Exception Request No.: 2 (Rev 2)
Town: Plymouth
Highway: US 3 (Tier 2)
Section: WBR3
Station: 2688+00 to 2690+25±
Drawing No.: WBR3 C242
Survey Report Cross Reference No.: WBR3 C238
Exception Type: Alignment in Pavement

NPT is requesting an exception from the UAM guidelines for the location of the cable trench in the pavement on US 3, Daniel Webster Highway from STA 2688+00 to 2690+25± of the NPT WBR3 Underground Alignment. (See Exhibit A.)

EXCEPTION 2-ALIGNMENT IN PAVEMENT AND CROSSING EXISTING UTILITY
WBR3-UNDERGROUND ALIGNMENT
STA 2688+00 TO 2690+25
SCALE: H. 1"=30', V. 1"=10'
DATE: 10/26/2016
DES: TDD
CHK: MRR
DRW: TDD
APR: TMY
TOWN:
PLYMOUTH

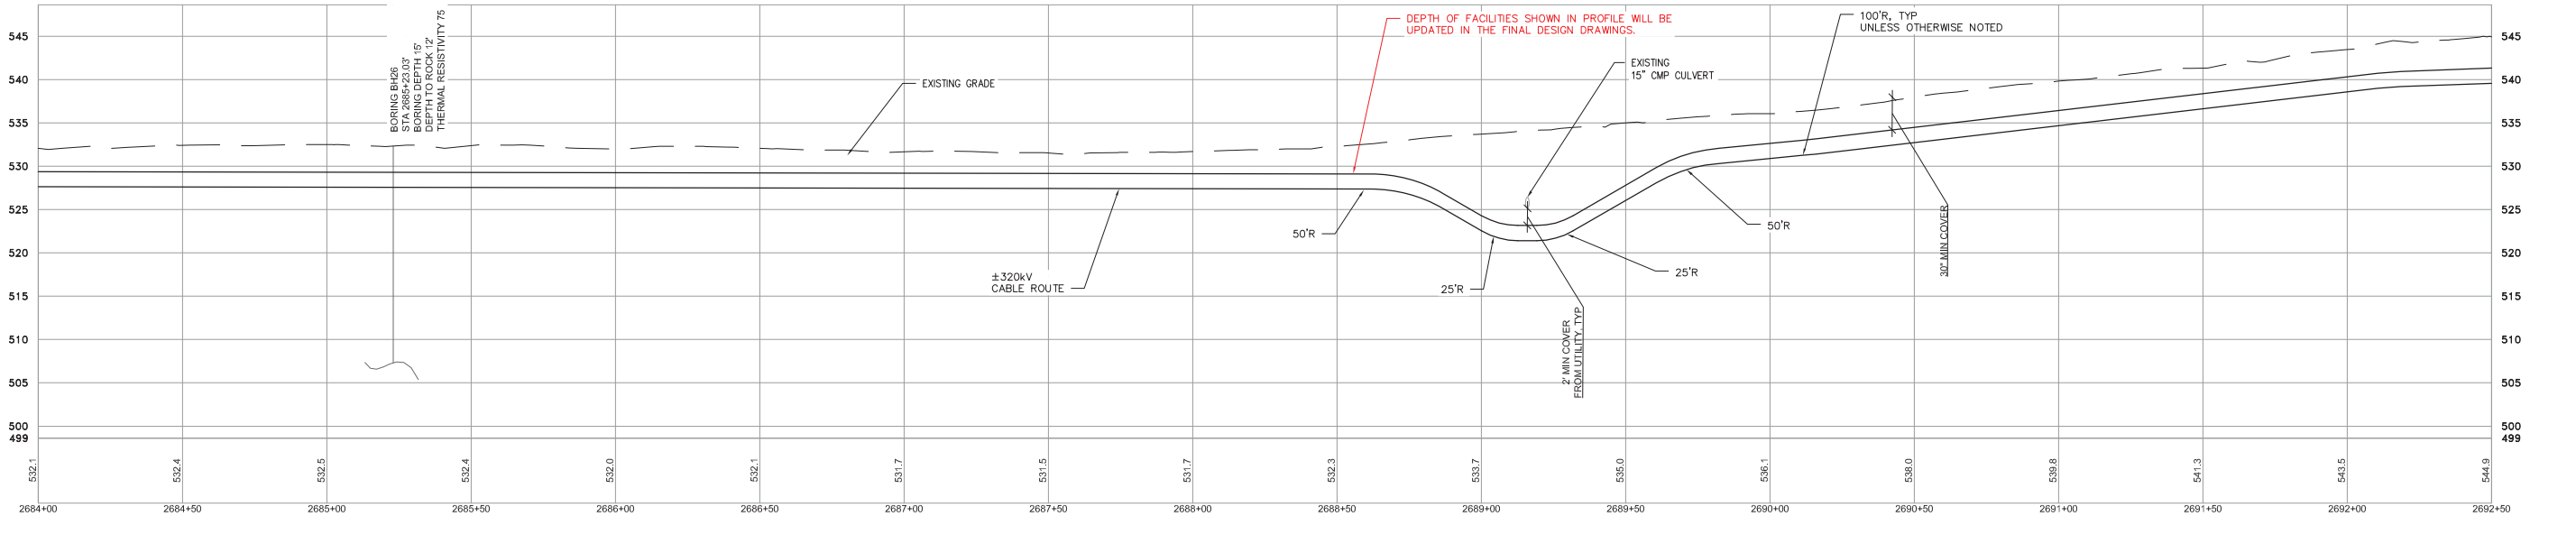
Excavation limits and work areas are shown on the attached drawings. During construction, one lane will remain open to traffic at all times.

EXHIBIT NO.: B

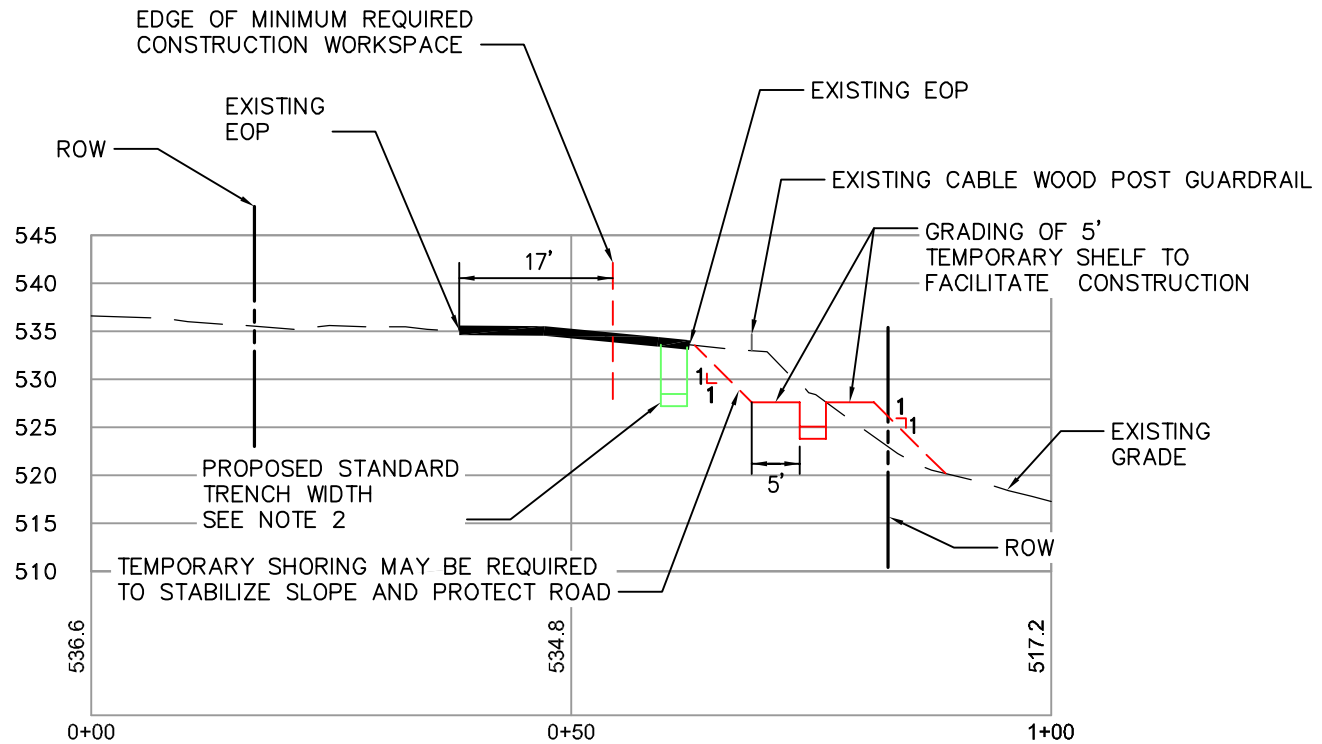
The roadway alignment at this location is constrained by guardrail on the eastern side of US 3 with moderate to steep slopes on the outside of the guardrails. (See Exhibit A and B.) Consequently, the steep slopes behind the guardrail, combined with NHDOT's requested offset of 5-feet from the existing guardrail, would result in significant constructability issues (if the guardrail were not removed), including the need for benching into the side slope to create a level and safe working area. The modified side slopes would extend beyond the ROW limits. (See Exhibit B.)

EXHIBIT NO.: C

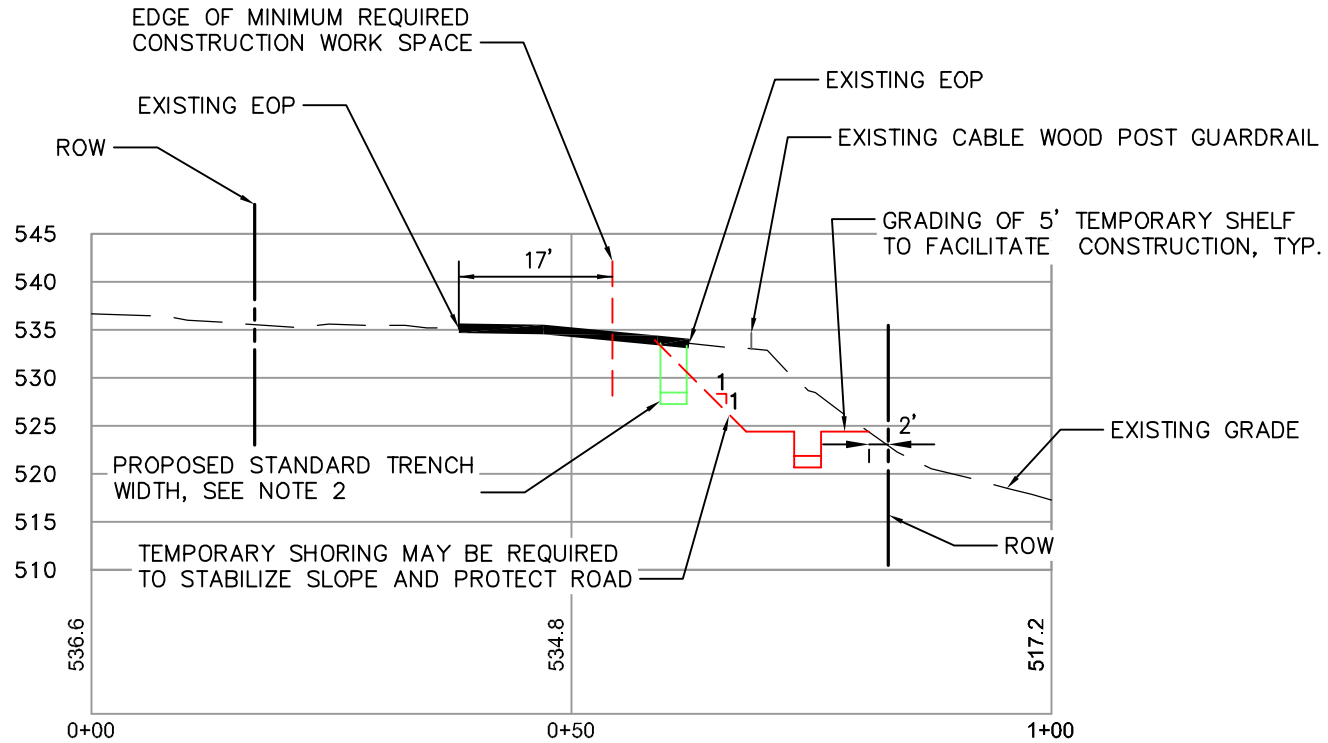
At the request of the DOT, we also evaluated an option to remove the guardrail and a portion of the roadway to allow NPT to construct the ductbank in the slope without extending past the right of way limits. Considerable amounts of materials would have to be removed and transported to another site for temporary storage in order to bench into the slope. These materials would then have to be transported back to the site to restore the site after the ductbank was completed. (See Exhibit C.) This

option would significantly increase the time necessary in the NH DOT ROW required to construct the ductbank and would be more costly, having a net increase of \$23,362 including the cost of material transport and new guardrail installation. (See Exhibit D). (Note: This marginal cost estimate does not factor in the potential that native materials cannot be used during reburial because more expensive, select materials may be needed to address cable thermal issues.) In addition, traffic impacts would be significantly greater for this option (as compared to the proposed installation) due to the additional work for the benching activities.

1. GUARDRAIL LENGTH: 112 FT
2. APPROX. CUT AREA: 102 SF
3. APPROX. CUT VOLUME: 11,424 CF (423 CY)
